Service Bulletin

Outboard No. 2017-02R1

200XS, 250XS, 300XS, and DSI Air Compressor Reed Failure

NOTICE
Revised June 2017. This bulletin supersedes the previous bulletin number 2017-02 March 2017.

Air compressor

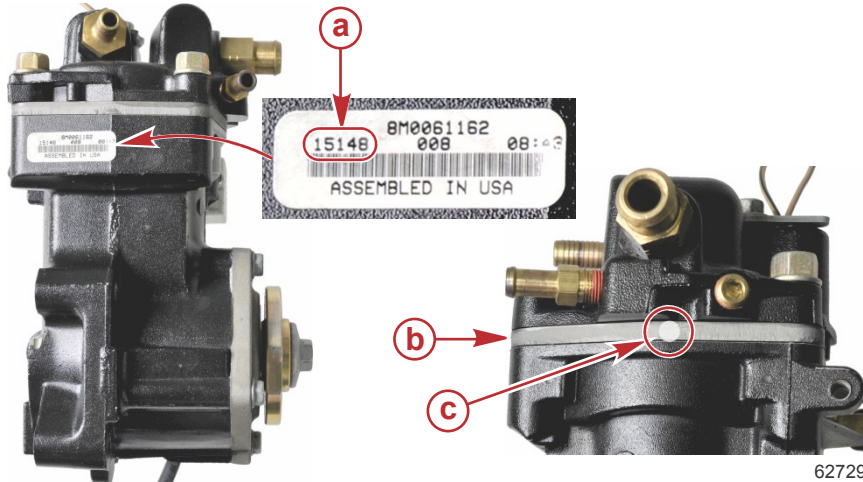
IMPORTANT: A white dot on the edge of the reed plate assembly indicates the reed plate assembly has been replaced. Do not rework a compressor with a white dot on the edge of the reed plate assembly.

Check the engine to confirm whether the air compressor is an affected unit. If no white dot is present and the engine serial number falls within the range specified at the top of this service bulletin, replace the reed plate assembly.

Inspect all in-stock replacement air compressors. If no white dot is present and the Julian date code falls between 14189 (July 8, 2014) and 16246 (September 2, 2016), inclusive, replace the reed plate assembly.

Reed plate assembly

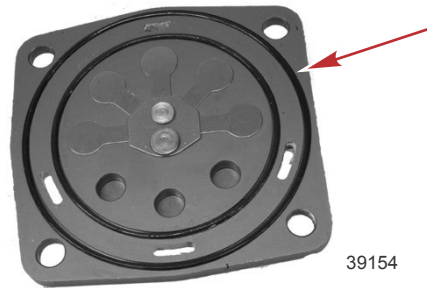
Reed plate assembly, p/n 835088A10.

Port Fuel Rail Disengagement (2.5L Only)

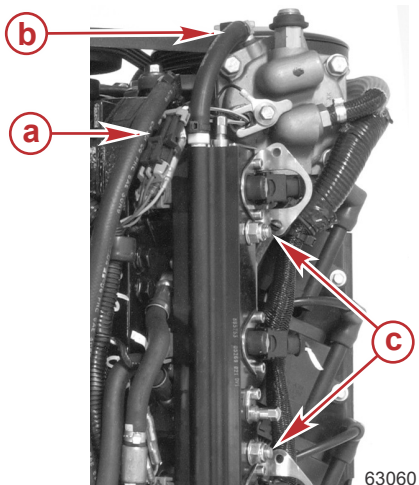
In order to access the lower left-hand screw on the air compressor cylinder head on 2.5L models, the port fuel rail must be temporarily disengaged and moved out of the way.

1. Disconnect the cylinder head temperature sensor harness connector.
2. Disconnect the compressor water inlet hose.

3. Remove the two fuel rail mounting nuts.

4. Without removing the lower cowl, position the fuel rail out of the way, and complete the reed plate assembly replacement. Before putting the engine back into service, be certain to reconnect all items and tighten the fuel rail mounting nuts to the specified torque.

Reed plate assembly edge marked with a white dot

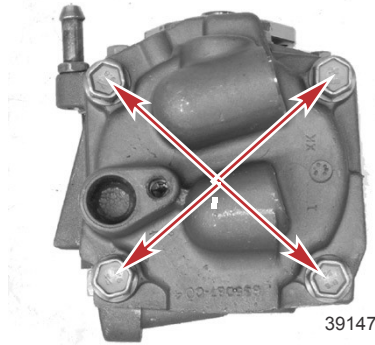
- To indicate that the rework procedure has been completed, mark the top edge of the replacement reed plate assembly with a white dot.
